Wisconsin Department of Transportation

NOTICE TO ALL CONTRACTORS:

Proposal #58: 1517-07-74
USH 10 – USH 10/STH 441
County CB – Oneida Street
I-41 (STH 441 - CTH II)
USH 10
Winnebago County

This is Addendum No. 01, which provides for the following:

Addendum No. 01
ID 1517-07-74
Added Sheet 45A
April 18, 2016

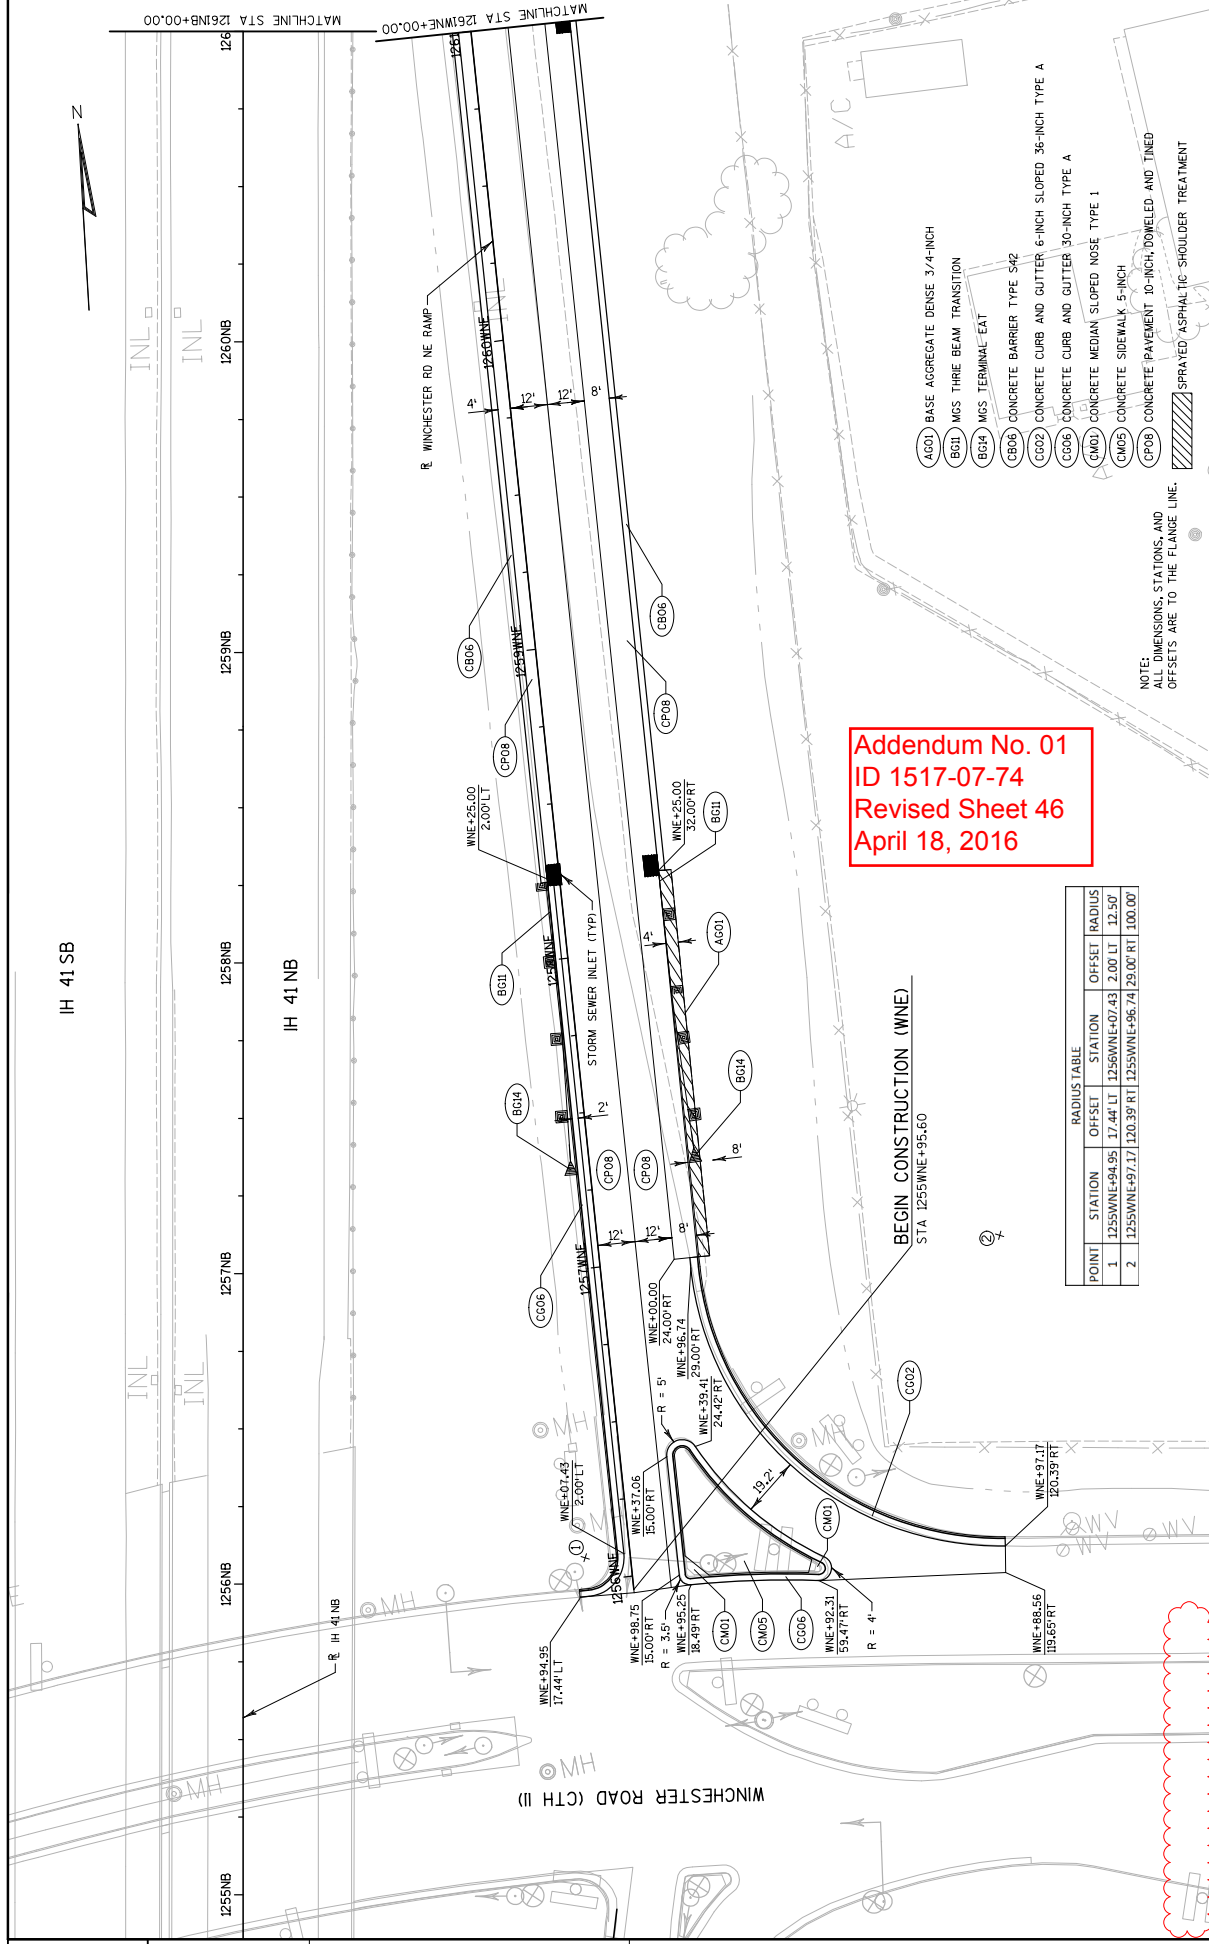
Added Plan Sheets	
Plan Sheet	Plan Sheet Title (brief description of why sheet was added)
45A	Construction Detail (Pull Box, Non-conductive)
140A	Storm Sewer (WNW Ramp)
187A	Lighting Plan (Underdeck lighting Winchester Road)
187B	Traffic Signal Plan – Winchester Road with WSW/WNW Ramps
187C	Traffic Signal Plan – Winchester Road with WSW/WNW Ramps
187D	Traffic Signal Plan – Winchester Road with WSE/WNE Ramps
187E	Traffic Signal Plan – Winchester Road with WSE/WNE Ramps
208A	Stage Construction Plan – Stage 3 (Added a Stage 3)
239A	TC Overview – Stage 3
239B	TC Mainline – Stage 3 Sheet 1 NB
239C	TC Mainline – Stage 3A Sheet 2 SB
239D	TC Mainline – Stage 3A Sheet 3 SB
239E	TC Mainline – Stage 3B Sheet 4 SB
239F	TC Mainline – Stage 3B Sheet 5 SB
301A	Miscellaneous Quantities (New Traffic Signal quantities)
301B	Miscellaneous Quantities (New Traffic Signal quantities)
301C	Miscellaneous Quantities (New Traffic Signal quantities)

Addendum No. 01
ID 1517-07-74
Revised Sheet 46
April 18, 2016

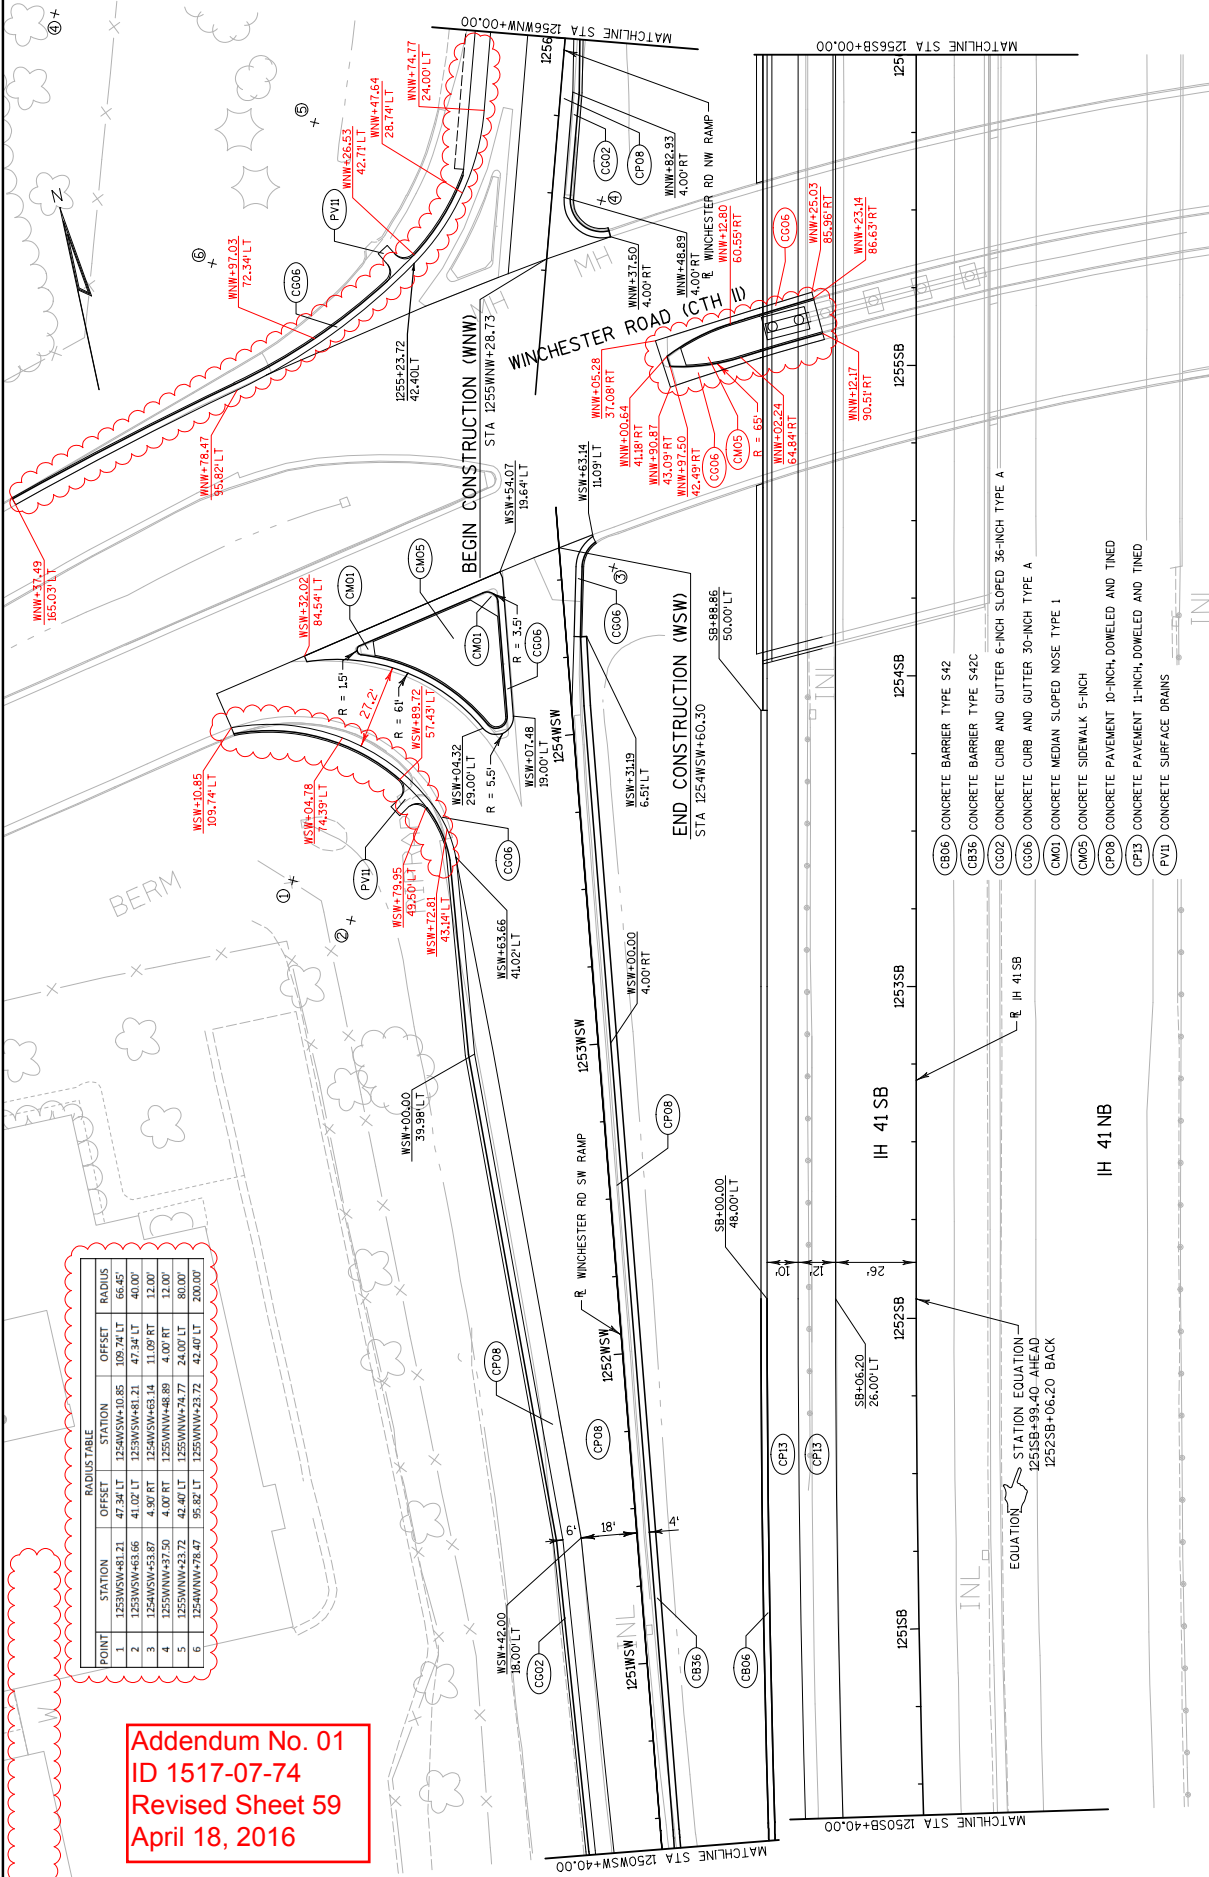
Revised Plan Sheets	
Plan Sheet	Plan Sheet Title (brief description of changes to sheet)
46	Plan Details (removal of note saying existing signals to remain)
59	Plan Details (Curve radius changed on WSW & WNW Ramp)
60	Plan Details (Curve radius changed on WNW Ramp)
73	Paving Grades (removal of note saying existing signals to remain)
85	Paving Grades (Curve radius changed on WSW & WNW Ramp)
86	Paving Grades (Curve radius changed on WNW Ramp)
100	Removal plan (removal of note saying existing signals to remain)
118	Temporary Erosion Control Plan (removal of note saying existing signals to remain)
125	Permanent Erosion Control Plan (removal of note saying existing signals to remain)
132	Storm Sewer (removal of note saying existing signals to remain and adding adjusting inlets)
188	Permanent Signing (Revisions due to Winchester intersection with IH 41)
191	Permanent Signing (Revisions due to Winchester intersection with IH 41)

Addendum No. 01  
 ID 1517-07-74  
 Revised Sheet 200  
 April 18, 2016

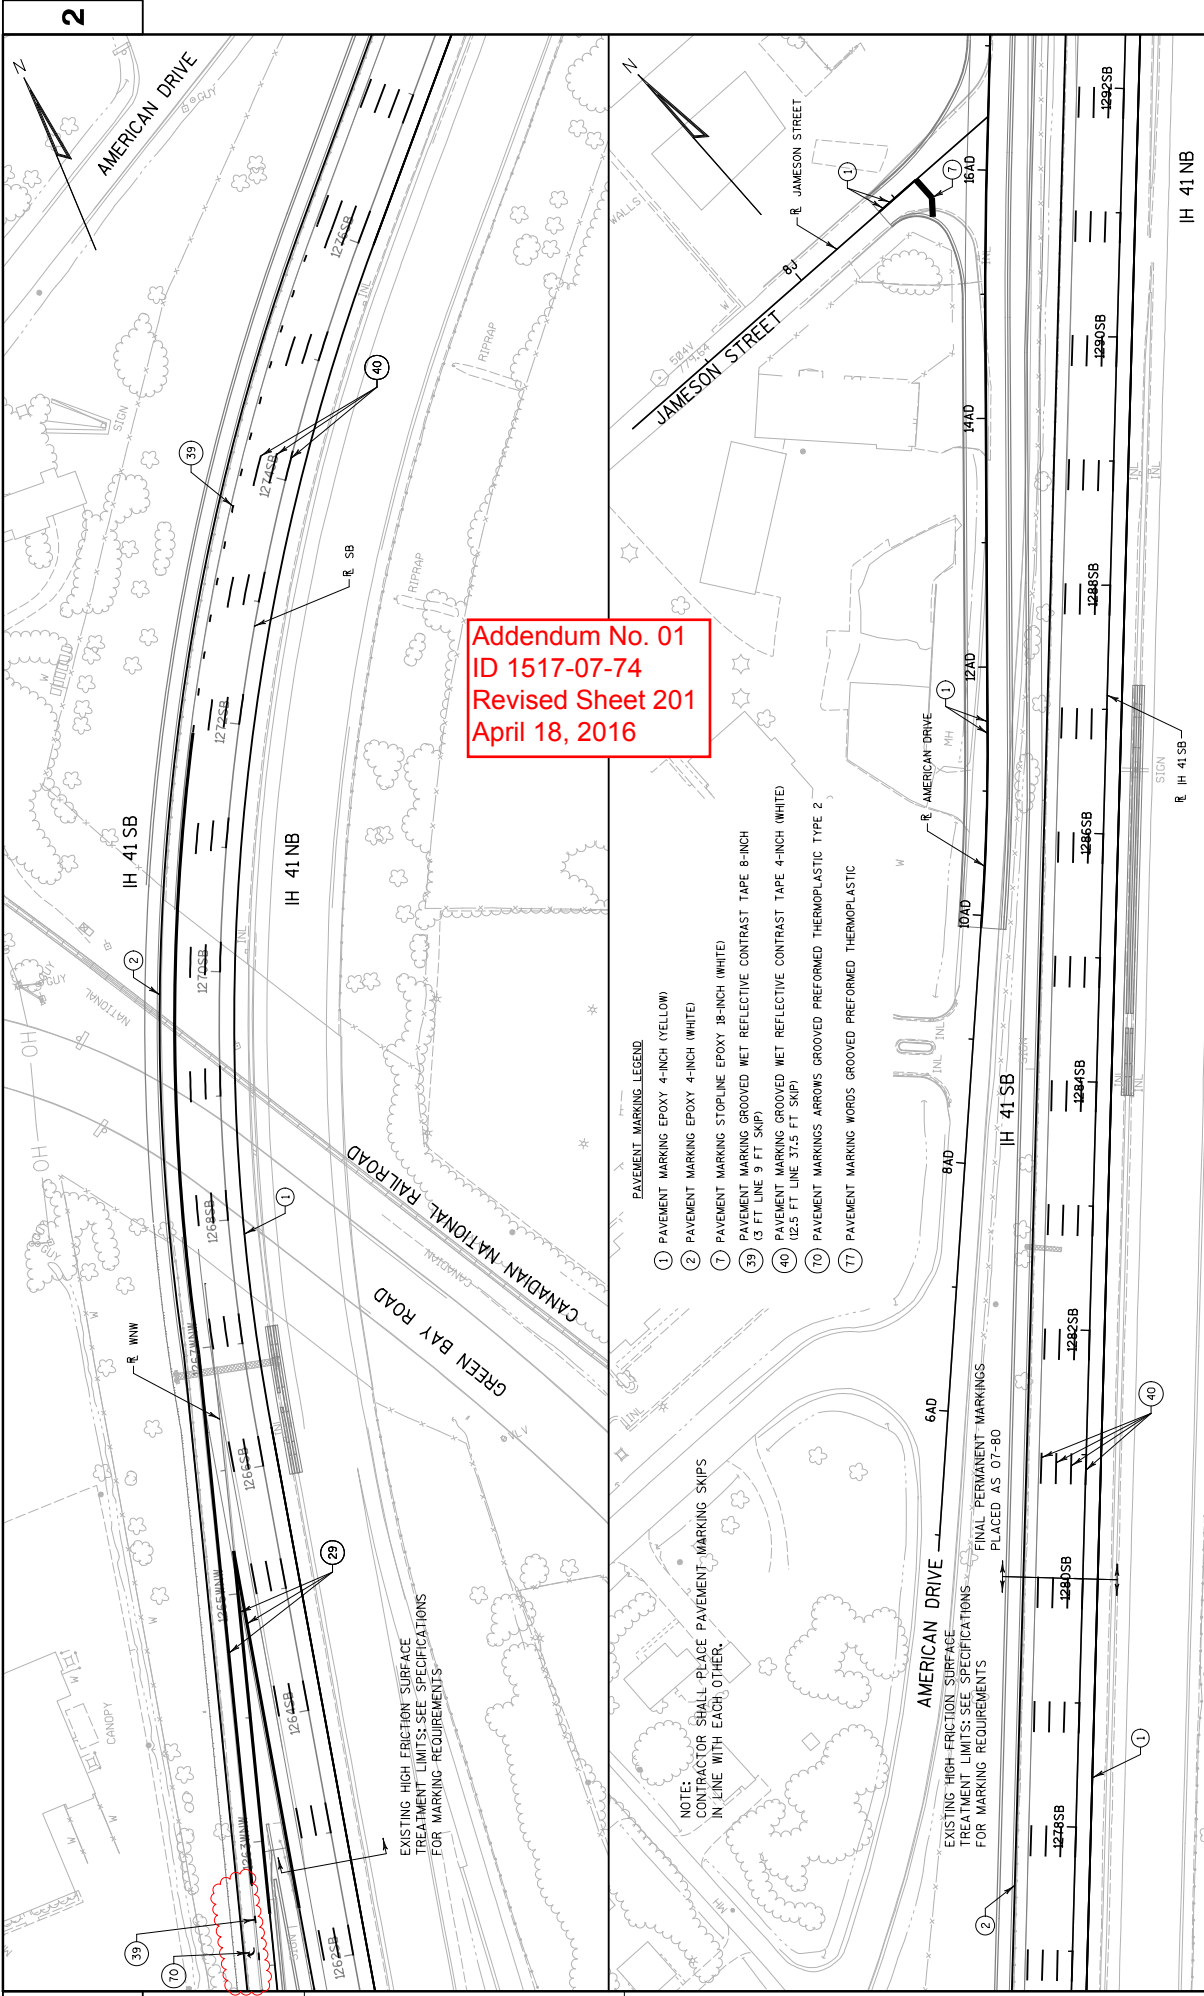
200	Pavement Marking IH 41 SB (WNW Ramp pavement marking revision)
201	Pavement Marking IH 41 SB WNW Ramp pavement marking revision)
207	Stage Construction Plan – Stage 2 (Added a B-70-130 Overlay)
208	Stage Construction Plan – Stage 2 (Added a B-70-130 Overlay)
223	Traffic Control – Typical Section Stage 2A, 2B & 3 (added stage 3)
270	Miscellaneous Quantities (Add adjusting storm sewer quantities)
271	Miscellaneous Quantities (Updated earthwork quantities)
273	Miscellaneous Quantities (Updated pavement quantities)
278	Miscellaneous Quantities (Added Survey Project quantities)
280	Miscellaneous Quantities (Updated concrete curb and gutter quantities)
281	Miscellaneous Quantities (Updated sidewalk & TC LIP quantities)
282	Miscellaneous Quantities (Updated concrete median slope nose quantities)

Addendum No. 01  
 ID 1517-07-74  
 Revised Sheet 761  
 April 18, 2016

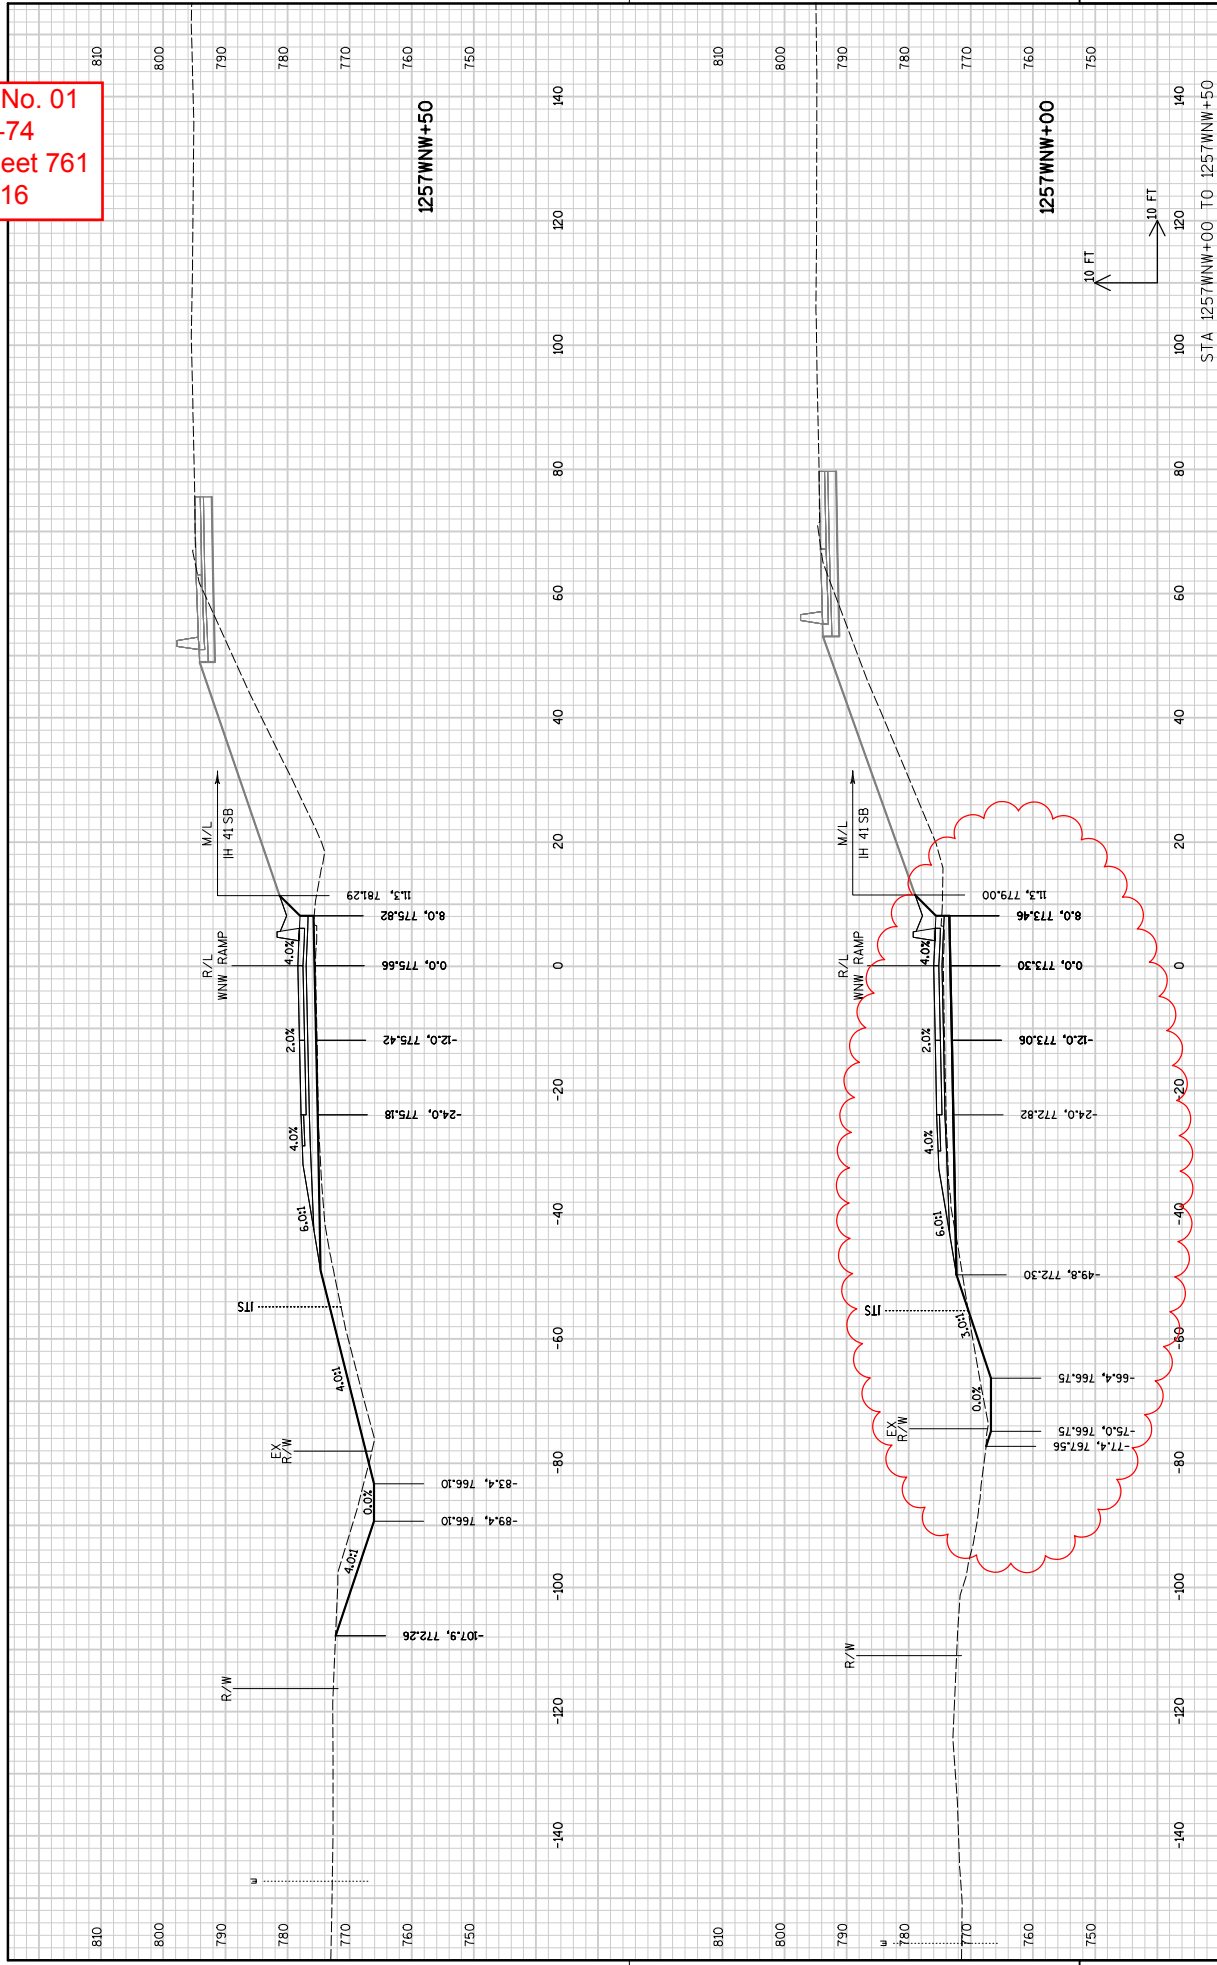
285	Miscellaneous Quantities (Updated Traffic Control quantities)
286	Miscellaneous Quantities (Updated crash cushion quantities)
287	Miscellaneous Quantities (Updated temporary pavement marking quantities)
288	Miscellaneous Quantities (Updated pavement marking quantities)
292	Miscellaneous Quantities (Updated Junction box and conduit quantities)
293	Miscellaneous Quantities (Updated pull box quantities)
300	Miscellaneous Quantities (Updated signing quantities)
495	Structure B-70-131 (Revised shy distance and removed TCB to be anchored)
623	Earthwork (WSW Ramp)
624	Earthwork (WNW Ramp)
757	Cross Sections - Winchester SW Ramp (Curve radius changed on WSW Ramp)
758	Cross Sections - Winchester SW Ramp (Curve radius changed on WSW Ramp)
759	Cross Sections - Winchester NW Ramp (Curve radius changed on WNW Ramp)
760	Cross Sections - Winchester NW Ramp (Curve radius changed on WNW Ramp)
761	Cross Sections - Winchester NW Ramp (Curve radius changed on WNW Ramp)
